# Muswellbrook Coal Continuation Project

## Response to Submissions

Report J16011RP1 | Prepared for Muswellbrook Coal Company Limited | 20 July 2016

**Land ownership and assessment locations**  
 Muswellbrook Coal Continued Operations Project  
 Response to submissions  
 Figure 2.1

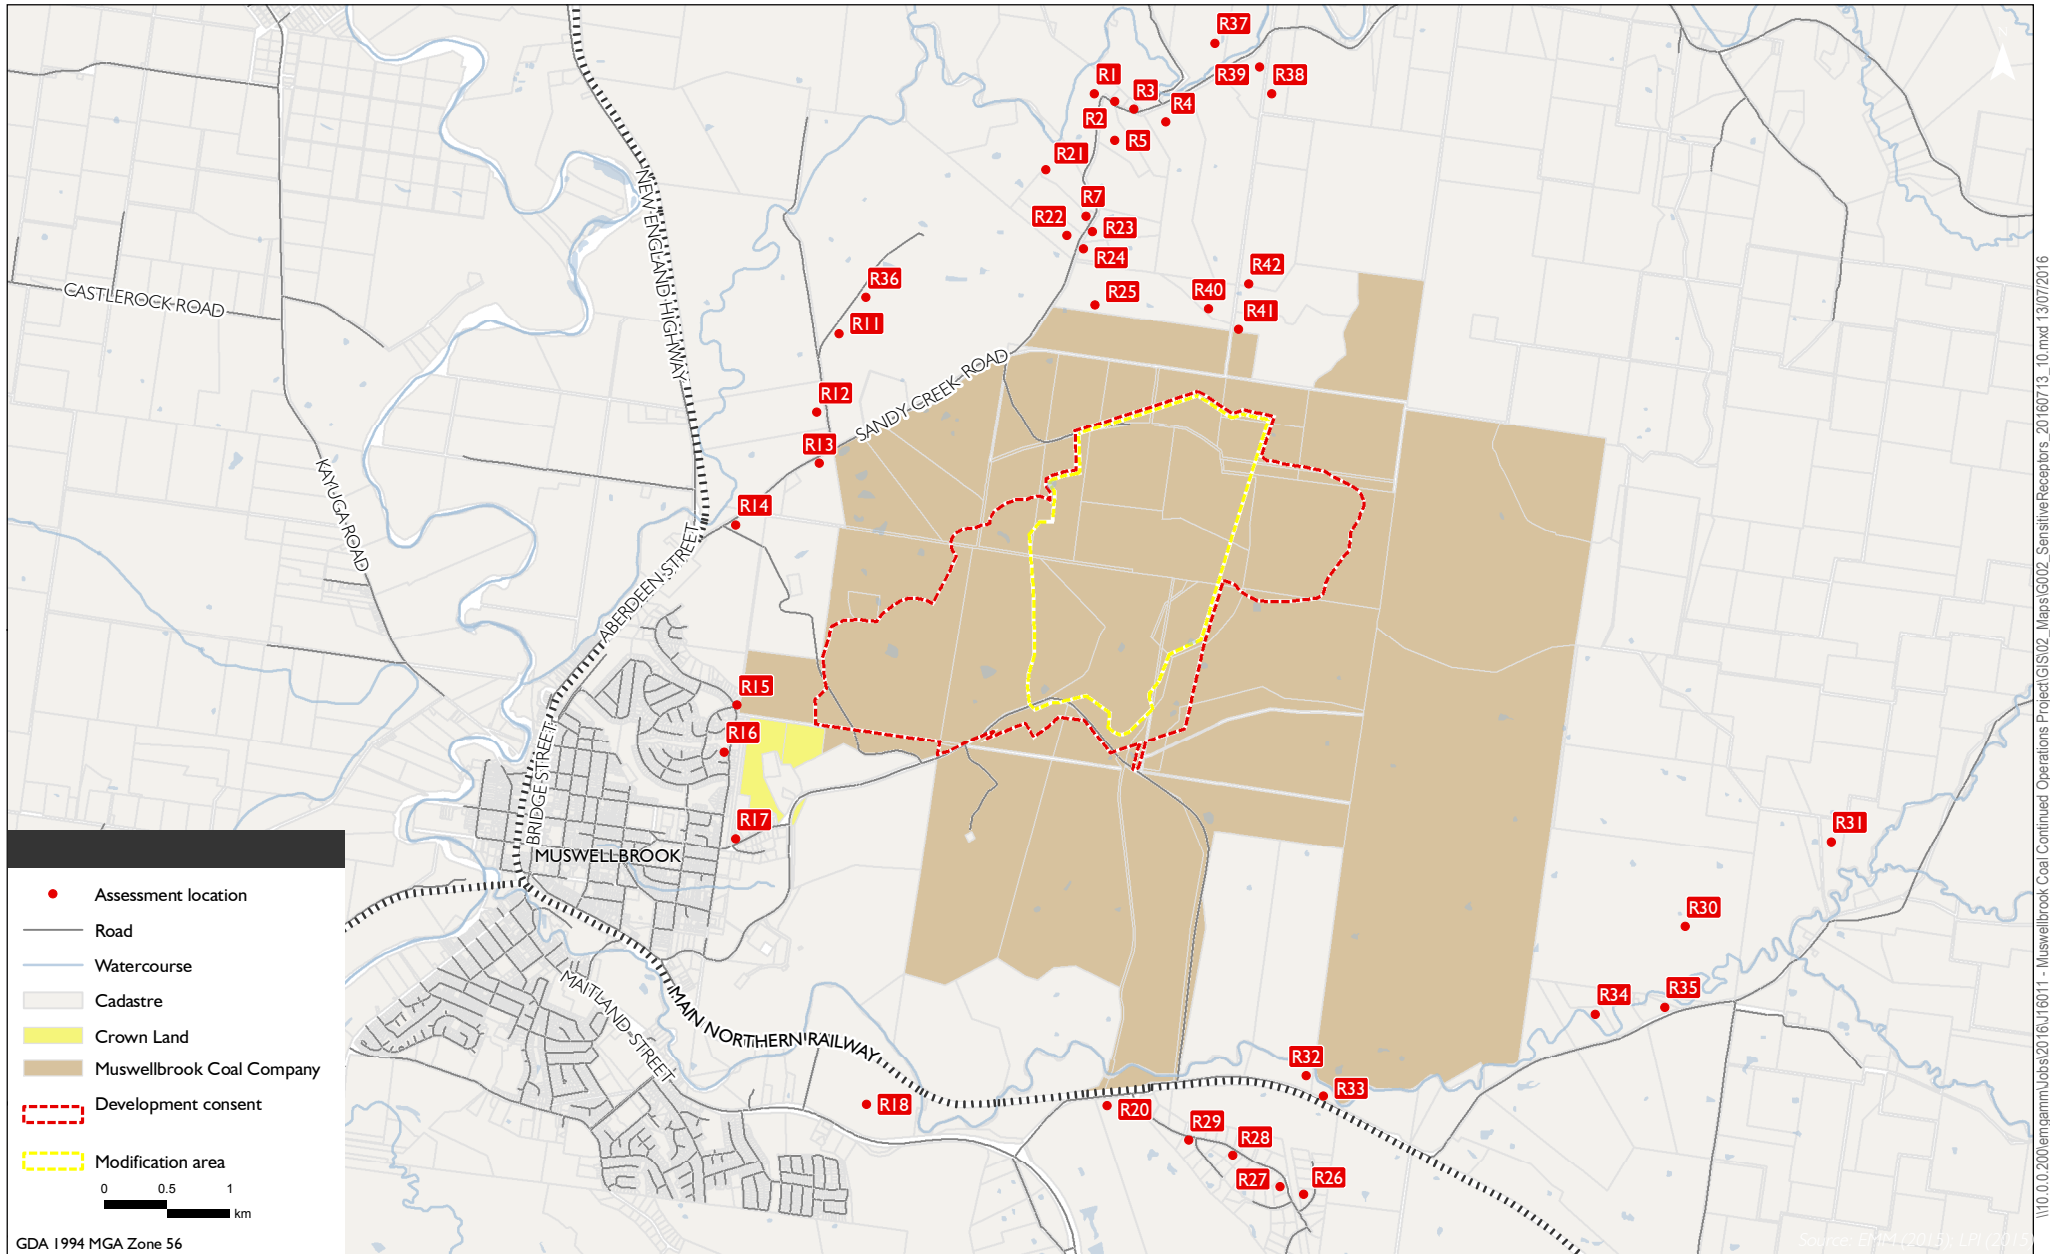
One submission identified three receptors to the north of MCM that were not assessed in the SEE. To rectify this, an updated receptor plan is presented in Figure 2.1, with the additional receptors labelled R40, R41 and R42 (located to the north of MCM). An assessment of noise impacts at these newly identified receptors is presented in Appendix B. Consideration of air quality impacts is included in Section 3.1.13.

One submission noted that potential impacts have not been adequately identified by MCC, nor have sufficient management strategies been put in place to address the potential impacts. Three properties were omitted from Figure 2.1 in the SEE.

As described above, three additional receptors have been identified that were not assessed in the SEE. These are identified as R40, 41 and R42 (see Figure 2.1). Receptor R40 is estimated to experience 24-hour PM<sub>10</sub> impacts greater than 50µg/m<sup>3</sup>. It is expected that impacts at R40 would be similar to those at R25 and would exceed 50µg/m<sup>3</sup> for up to three days of the year. Dust levels at all other receptors would be below the applicable criteria.

Photograph 3.1 Inert material above the Fleming seam in Open Cut 2

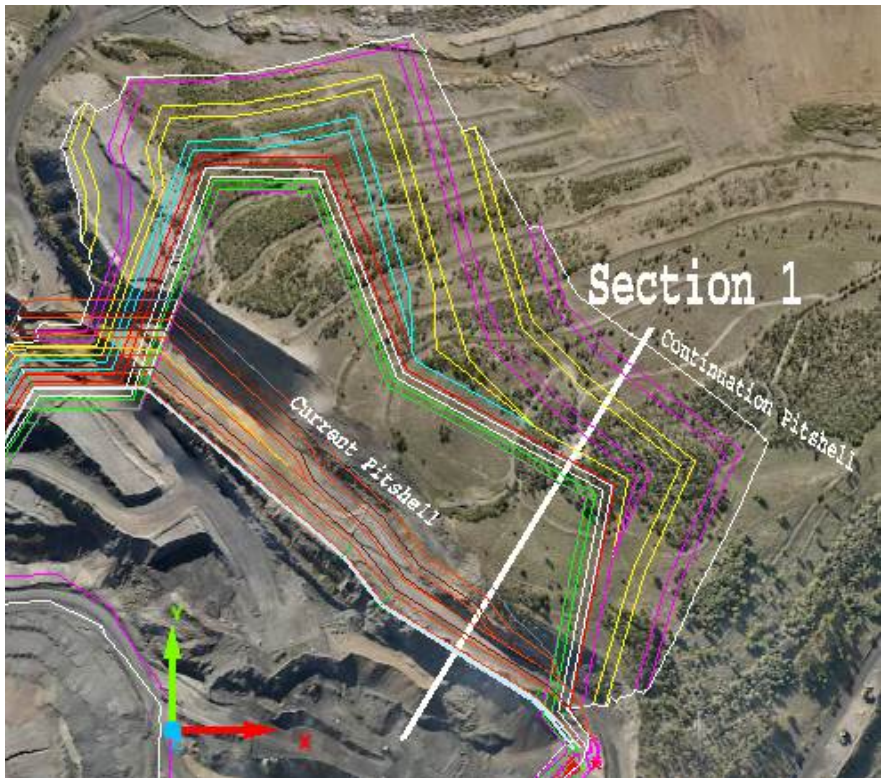
Photograph 3.2 shows the inert material from Open Cut 1 that is planned to be mined. There is also no sign of heating in this overburden, or any darker waste that indicates the presence of carbonaceous waste material.

Figure 3.1 RMS exclusion area

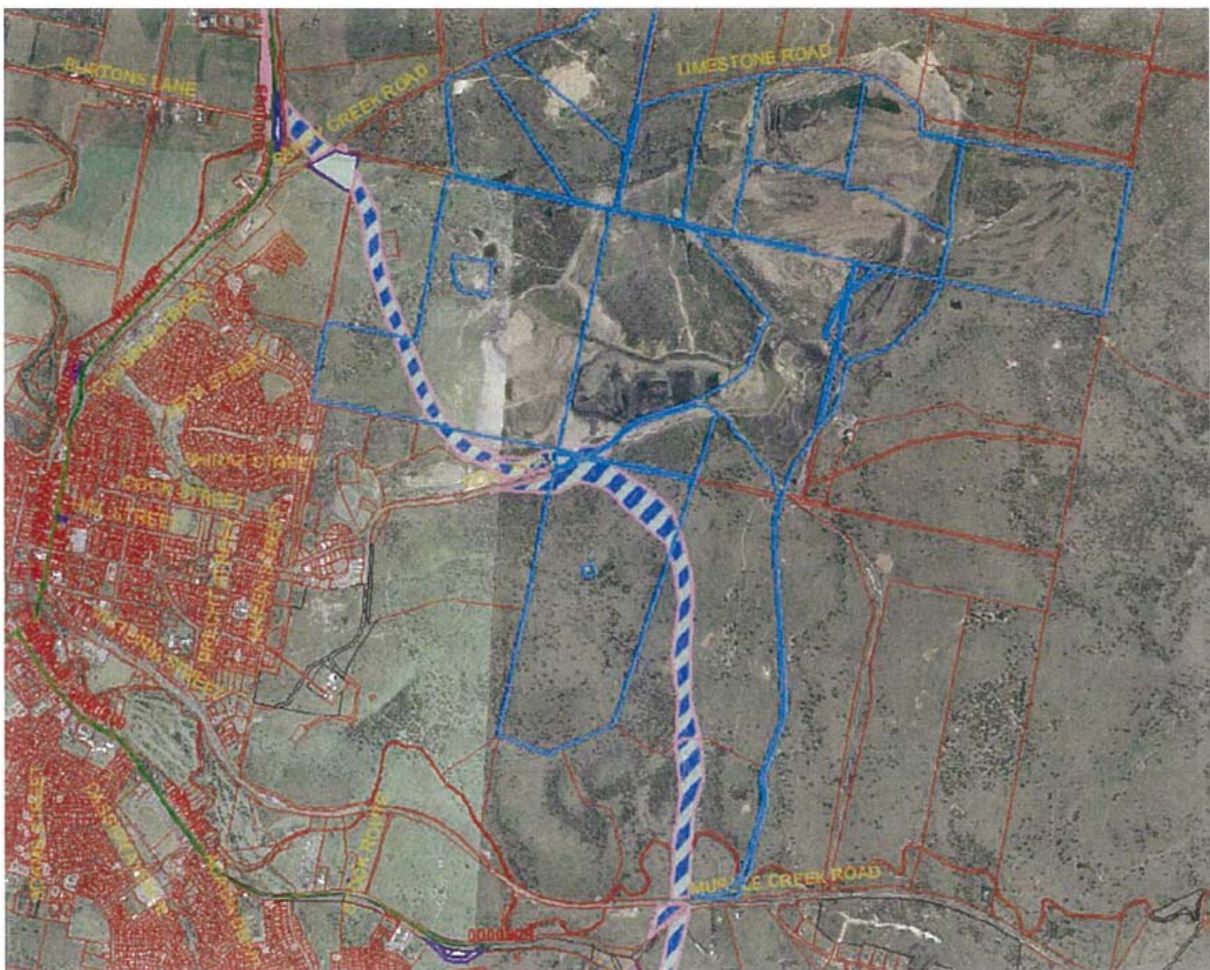
The property is within the study area for the Muswellbrook Bypass. The project is at the strategic design stage, with a preferred route having been selected. Any improvements and mining activities are to exclude the area shown hatched on the attached property image (Attachment 1).

Figure 3.1 below presents the property image referred to as Attachment 1 in RMS's submission. The modification area is excluded from the hatched area referred to by RMS. There are already conditions in the consent relating to restricting activities in this area.

**Figure 3.2 Spontaneous combustion complaints, January 2005 - June 2016**

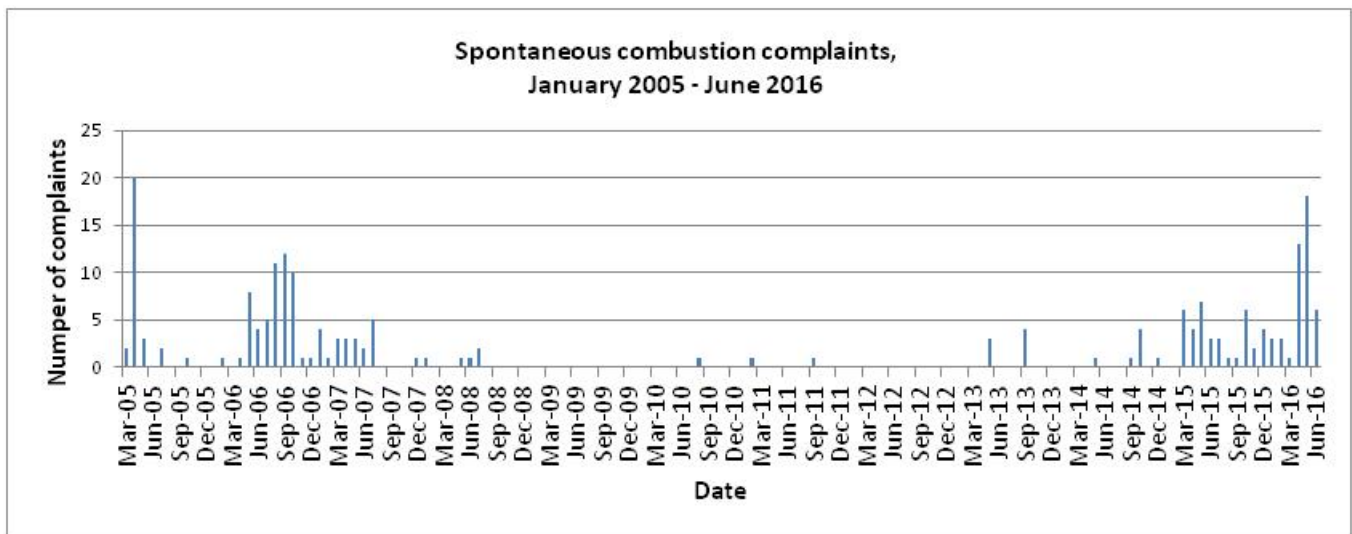
It is acknowledged that there has been a recent modest increase in the number of complaints relating to spontaneous combustion and associated odours and air quality impacts. MCC has reviewed its management of spontaneous combustion on site and has proposed a number of actions to be implemented as a result (see Table 3.2).

It is noted that, based on a review of MCC's complaints database in light of the recent increase in complaints relating to odour from spontaneous combustion (see Figure 3.2), it is evident that seasonal factors may play a role in the perceived impacts. Increases in complaints are observed in the months of late autumn, winter and early spring. Therefore, the recent increase in complaints is not inconsistent with observations from previous years. Nevertheless, MCC acknowledges the concerns of the community and regulatory agencies and is working to address the matter in consultation with relevant agencies.
